STAFF REPORT

RE: **21 Quay Road-Truman Waterfront Park; PAL Building, Horse Stables and Athletic Field**
(permit application # T2018-0025 and T2018-0026)

FROM: Karen DeMaria, City of Key West Urban Forestry Manager

Tree #86 and #87

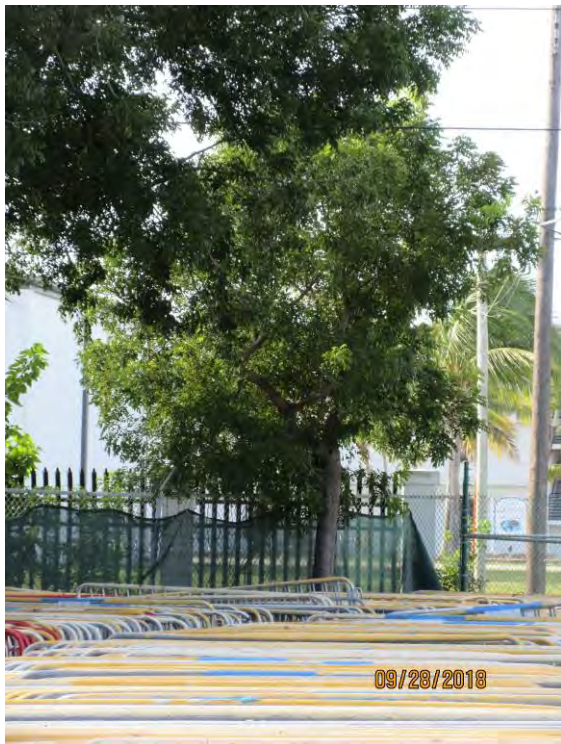
Tree #86 and #87 (old #17A and #17B)

Tree #108 & #109
(old #CC1 & #DD2)

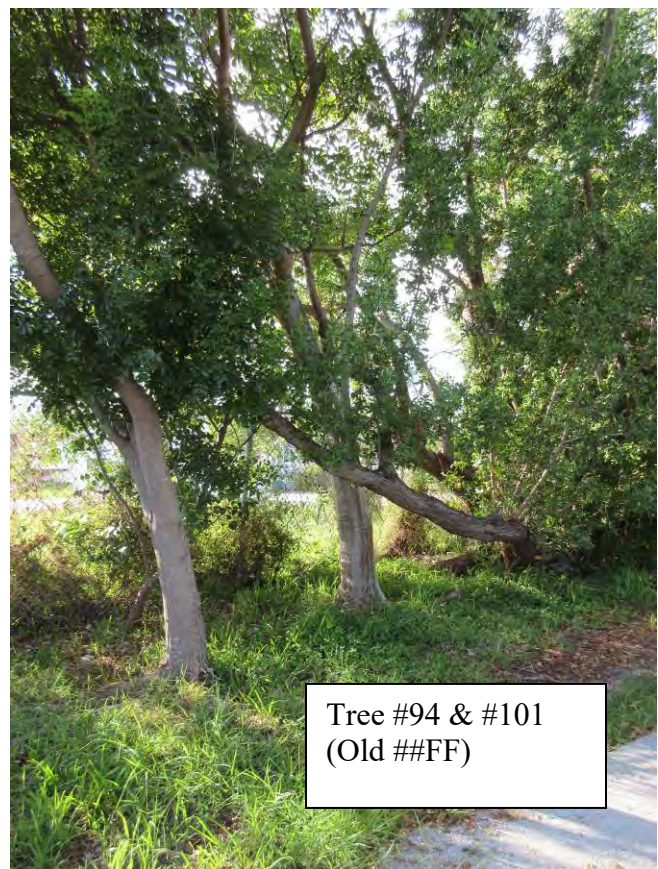
Trees and Palms to be Transplanted:
